RE: Response to TCEQ NOD 3 Addendum – CCR105
Luminant Generation Company LLC – Tatum, Rusk County
Industrial Solid Waste Registration No. 31277
EPA Identification No. TXD000821306
Tracking No. 27220868; RN102583093/CN603256413

Table 1 - NOD Summary and Response
Registration No. CCR105 - Luminant Generation Company LLC
Application Deficiencies - Addendum to NOD 3

RE: Response to TCEQ NOD 3 Addendum – CCR Registration No. CCR105
Martin Lake Steam Electric Station - Rusk and Panola Counties, Texas
(SWR 31277; RN102583093; CN603256413; EPA ID No. TXD000821306)

PDP-5 Groundwater Potentiometric Surface Maps - Background Period

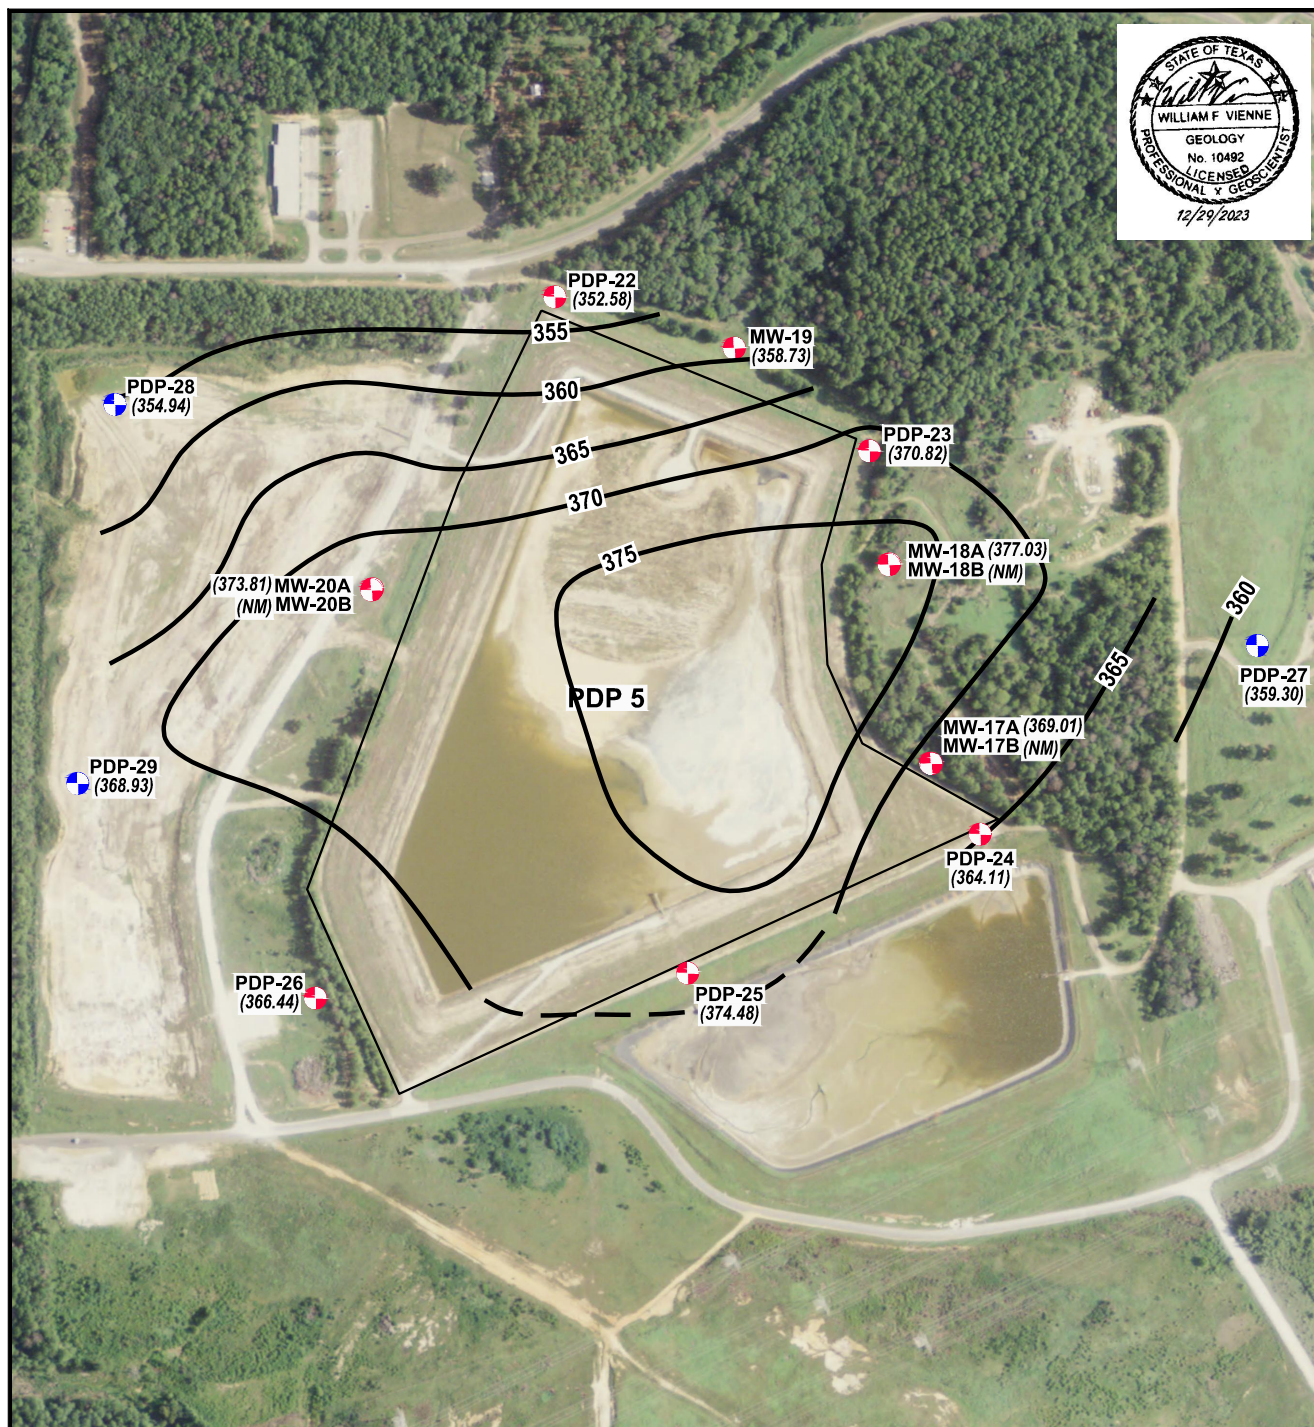
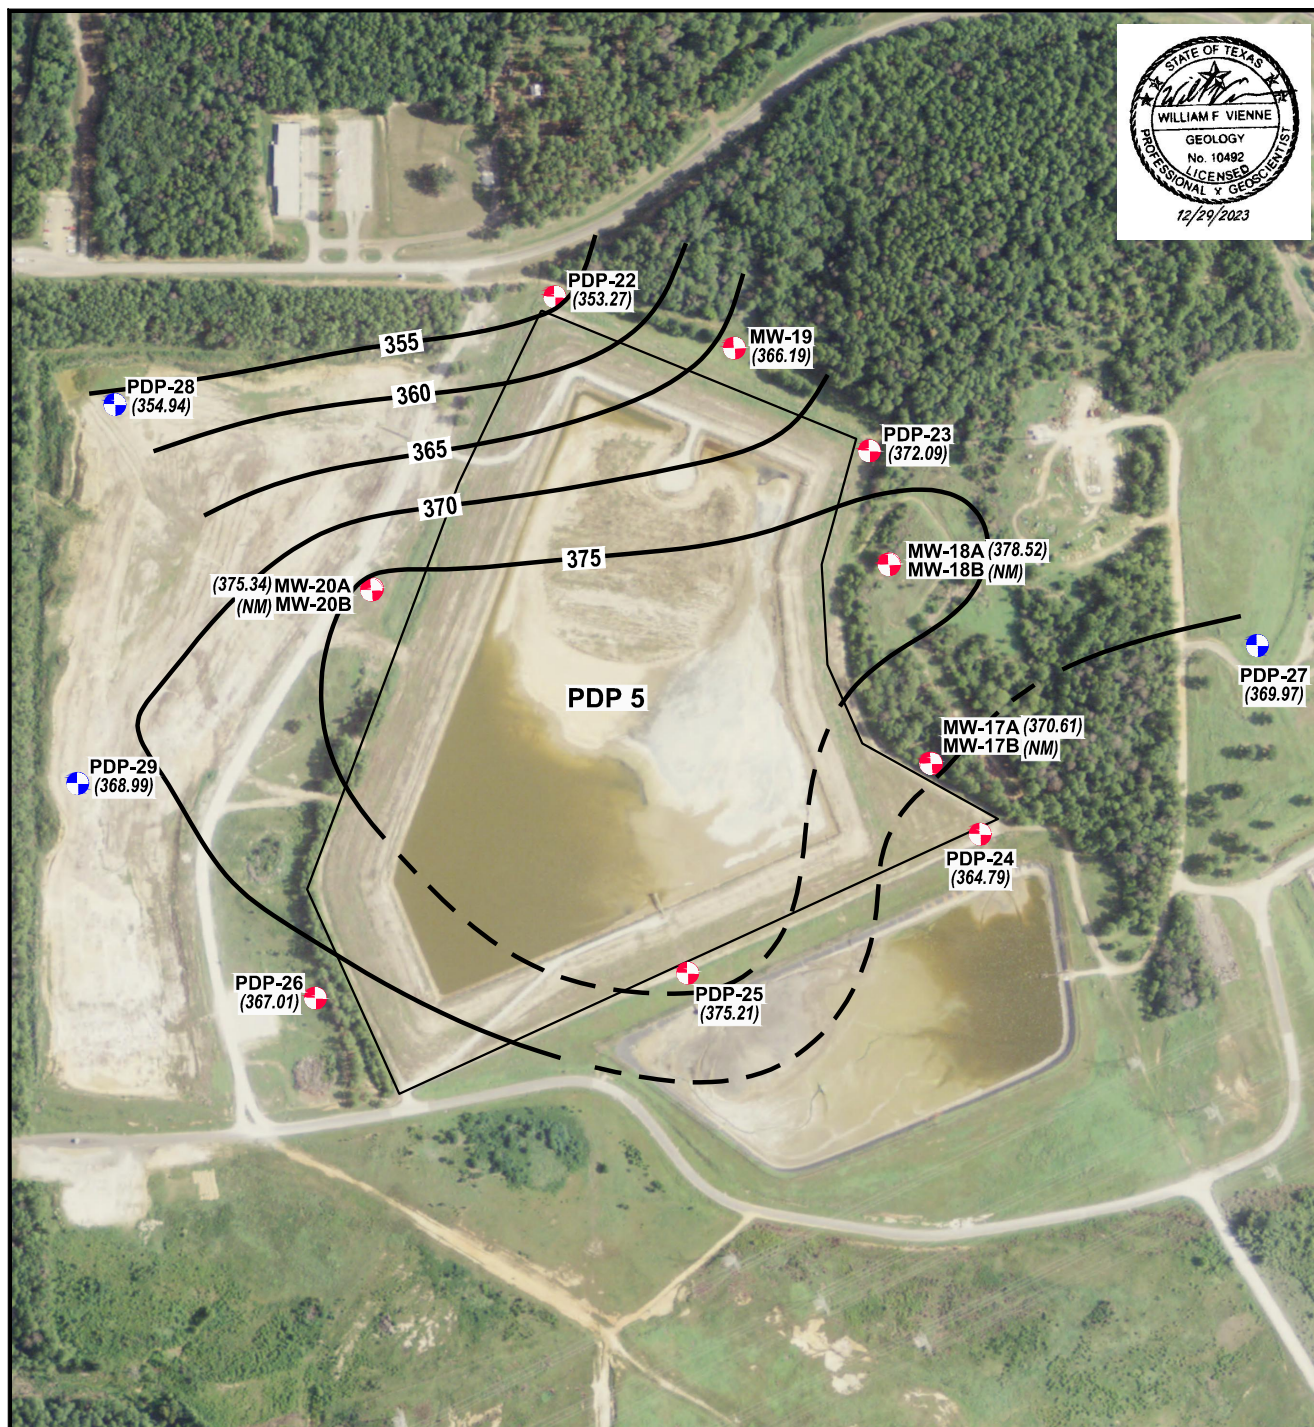
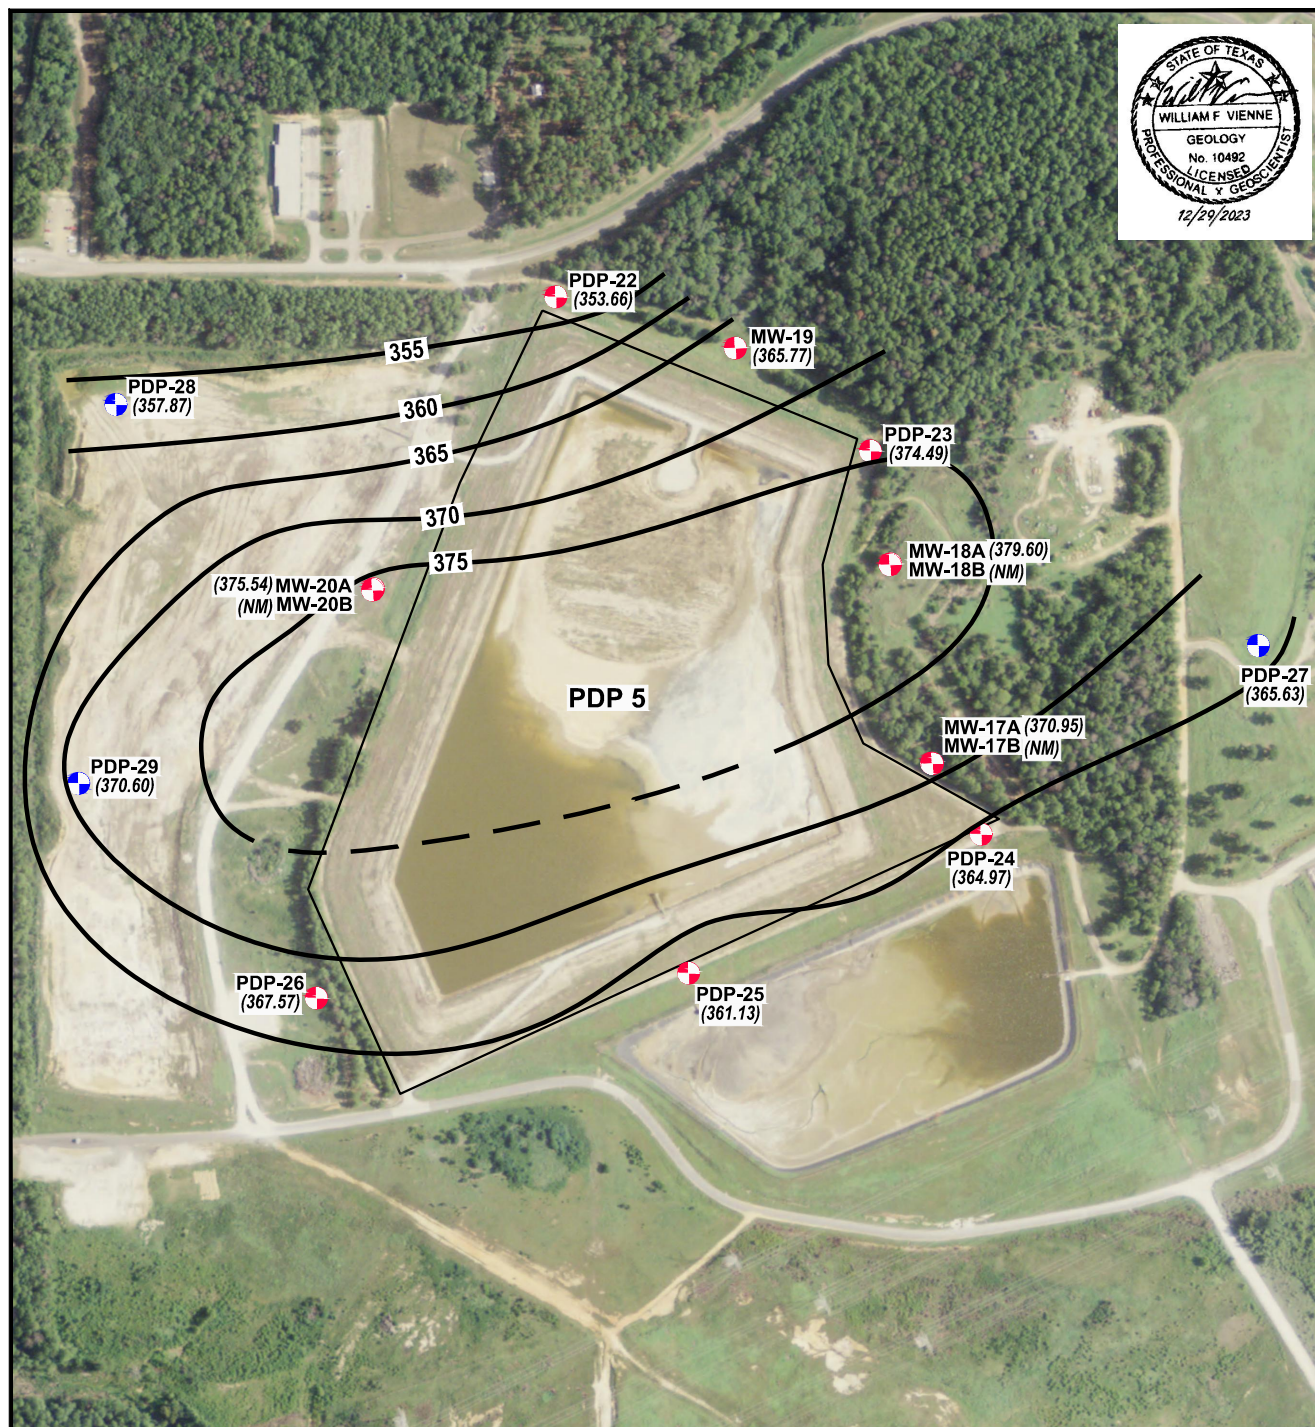
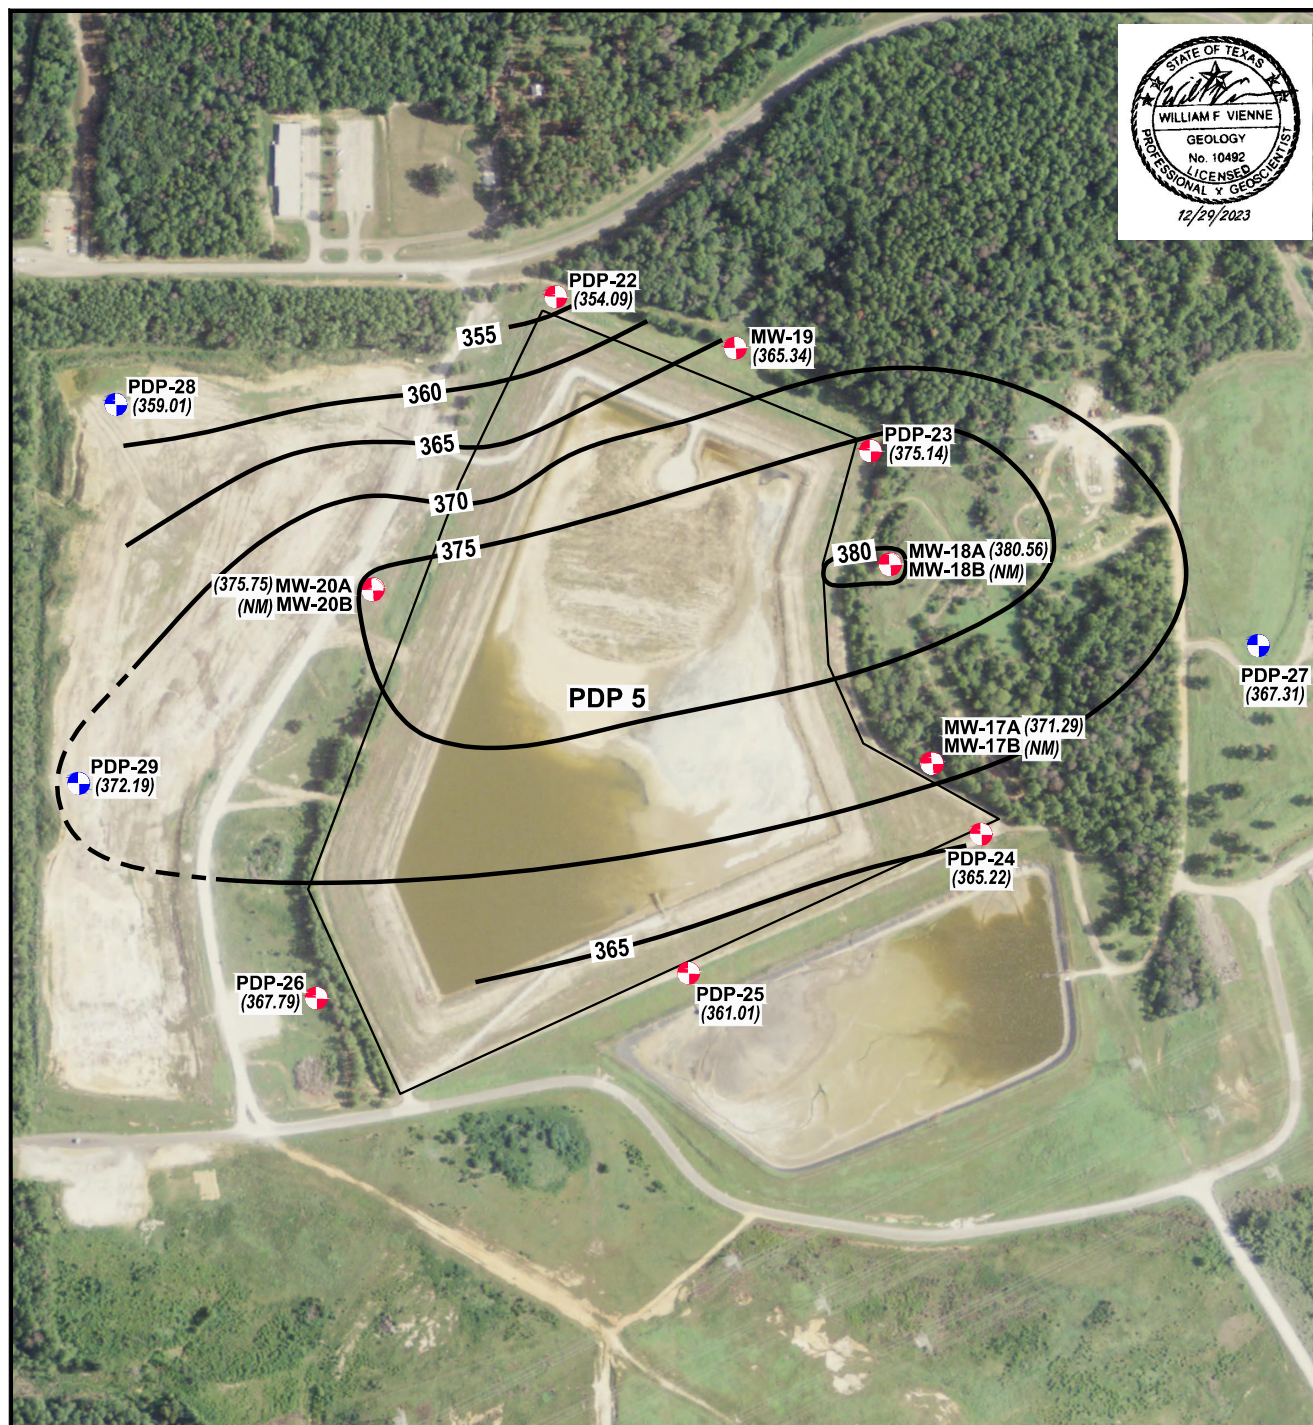
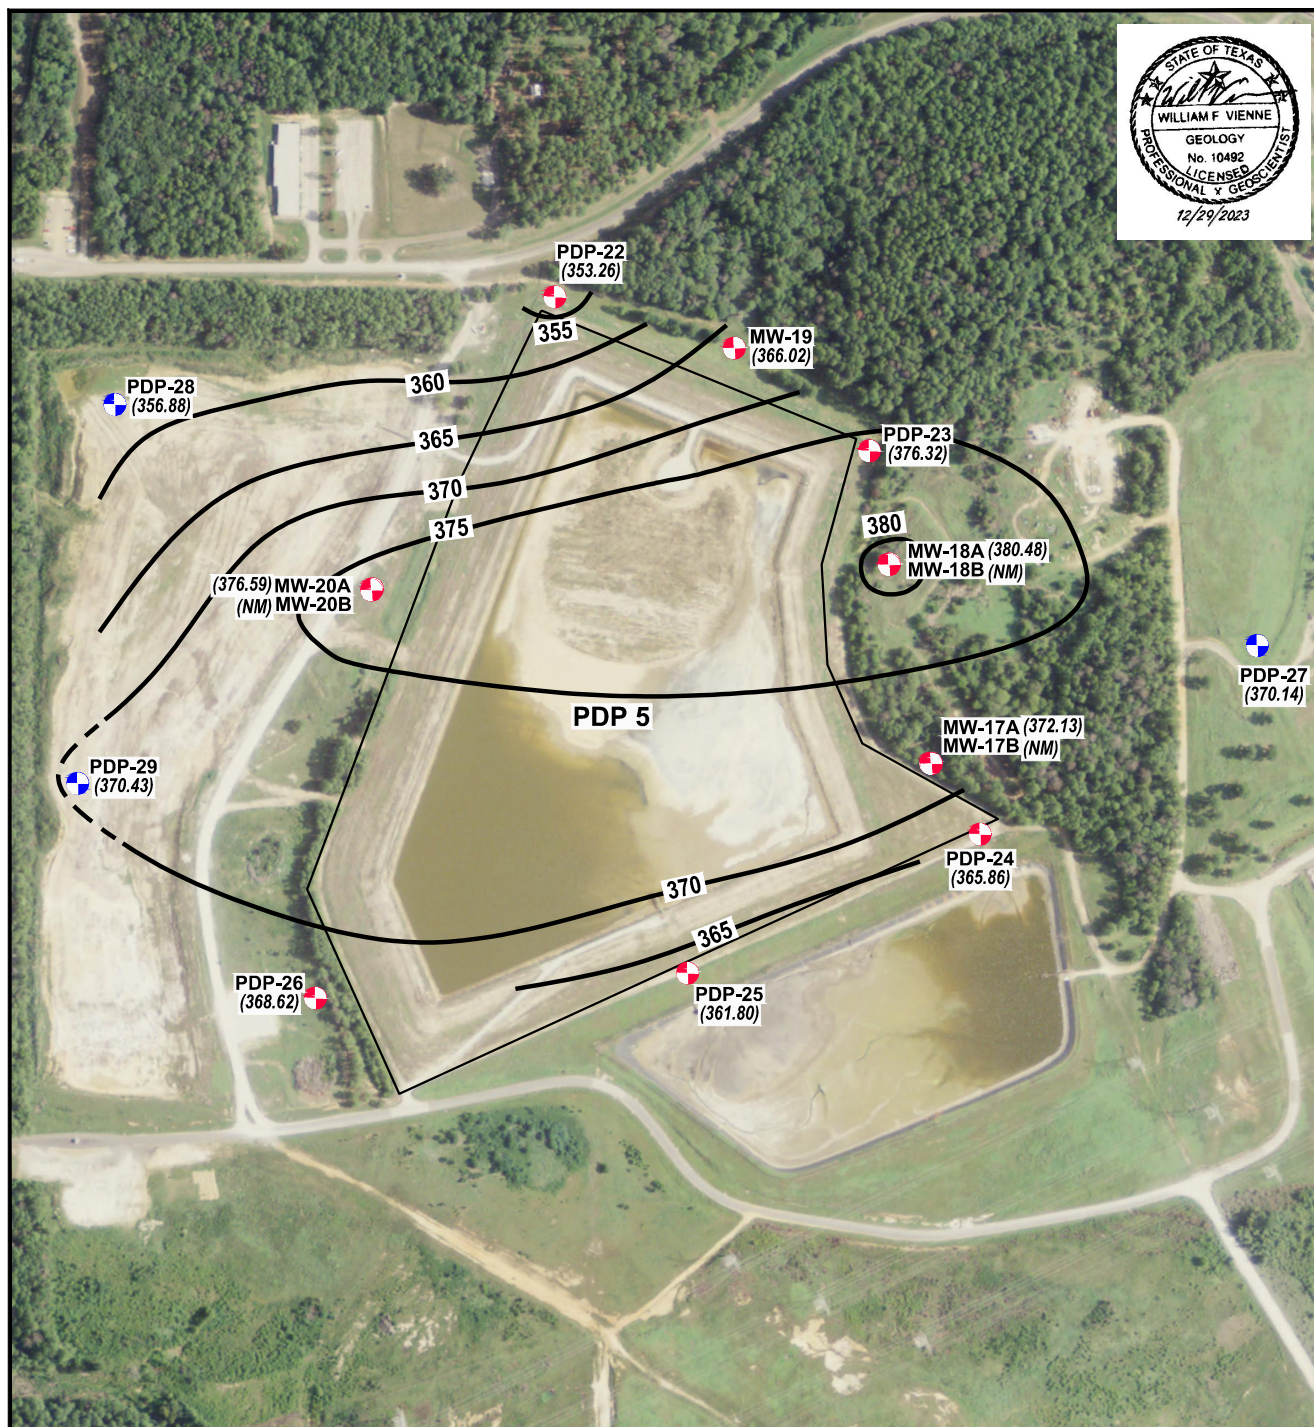
PDP5: Please provide a narrative that addresses the fact there is no true background well because of groundwater mounding and radial groundwater flow centered on well MW-18A.

PDP-5 was constructed in 2010, prior to the CCR Rule being issued by EPA in 2015. PDP-5 has been registered and regulated under the TCEQ IHW Program as industrial non-hazardous solid waste management unit No. 024 (TCEQ Solid Waste Registration No. 31277) since it was constructed. TCEQ reviewed the PDP-5 monitoring well network as part of the registration package that was submitted to and approved by the TCEQ IHW Program. Several monitoring wells have been replaced or added over time, but the current monitoring well locations are similar to those that the TCEQ approved as part of the IHW registration approval.
